Service Bulletin

NO. 322

Studebaker and Packard Clipper

POWER BRAKE UNIT NOISE - 1956-1957 STUDEBAKER AND 1957 PACKARD CLIPPER

Fig. 3

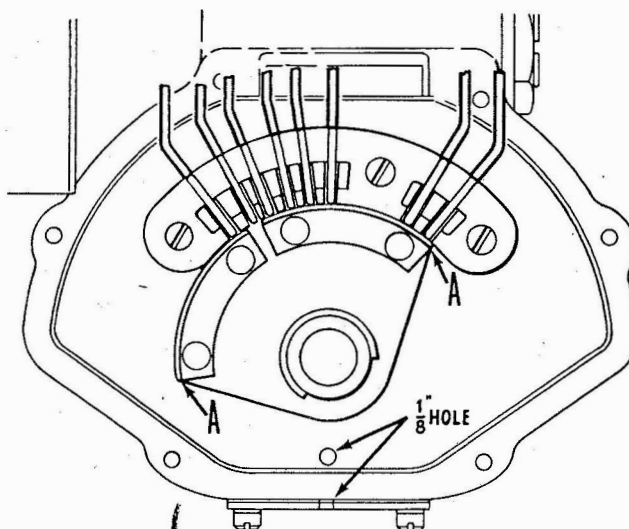
Drill a 1/8" hole at the center lower inner edge of the base plate to provide a vent into the lower main housing and another 1/8" hole in the inspection plate and gasket to provide a vent and drain from the main housing. Fig. 3 illustrates the approximate locations of the holes.

To prevent this interference when an overtravel occurs, round-off or chamfer the two corners (A, Fig. 3) of the contact segment.

This modification will also reduce the tendency of the transmission oil to seep past the seal. Therefore, it is recommended if the actuator is removed for any reason that the modification be made. Obviously, if a condition of oil in the actuator is encountered, also replace the seal.

This should be done when the segment is removed for any reason and the unit involved has sharp edges.
